Access Compliance Report

Public Rights-of-Way

(Curb Ramps)

Intersection ID: 50470	Main Street: EVERTON_DR	Cross Street: LENOX_POINTE_DR	Location: NE
ADA ID: 548F91920648	Ramp Type: Perp	Initial Pass/Fail: Pass	Overall Compliance: No
Severity Score: 0			
Codes/Mitigation Info/Possible Solution		Field Measurements/Component Compliance

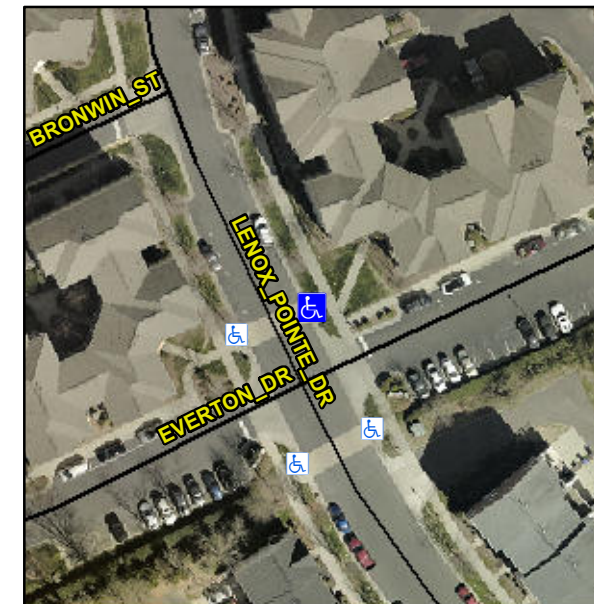
Not Found, R305.2

Compliance	Description	Data	Compliance	Description	Data
N/A	Ramp Length (in)	98.0	Yes	Ramp Slope (%)	6.0
Yes	Ramp Width (in)	59.5	Yes	Ramp XSlope (%)	1.2
N/A	Flare Type LT	Sloped	N/A	Flare Type RT	N/A
N/A	Flare Slope LT (%)	3.2	N/A	Flare Slope RT (%)	5.5
N/A	Flare Traversable LT?	No	N/A	Flare Traversable RT?	No
Yes	Landing Length (in)	72.0	Yes	DWS Provided?	Yes
Yes	Landing Width (in)	58.0	Yes	DWS Contrast?	Yes
Yes	Landing Slope (%)	1.0	Yes	DWS Length (in)	24.0
Yes	Landing X Slope (%)	0.3	Yes	DWS Full Width?	Yes
N/A	Landing Curb? (Y/N)	No	No	DWS Offset (in)	4.5
N/A	Shared Landing?	No			
Yes	Gutter Ponding?	No	Yes	Gutter Slope (%)	1.9
Yes	Gutter Lip Ht (in)	0.0	Yes	Gutter X Slope (%)	1.2
N/A	Painted X Walk1?	Yes	N/A	Painted X Walk2?	N/A
	X Walk 1 Direction	To W		X Walk 2 Direction	N/A
N/A	X Walk 1 Width (in)	144.0	N/A	X Walk 2 Width (in)	N/A
	X Walk 1 Slope (%)	0.7		X Walk 2 Slope (%)	N/A
	X Walk 1 X Slope (%)	0.3		X Walk 2 X Slope (%)	N/A

Yes	Ramp inside XWalk1?	Yes	N/A	Ramp inside XWalk2?	N/A
	Road Slope (%)	N/A	N/A	Clear Space?	Yes
	Road X Slope (%)	N/A	N/A	Clear Space to XWalk (in)	N/A
Yes	Any Obstructions?	No	Yes	Storm Grate/Utility Hazard?	No
	Obstruction Type			Storm Grate/Utility Type	
		N/A			N/A
			Yes	Surface Condition? (G/P)	Good

Remove & Replace Entire Ramp.
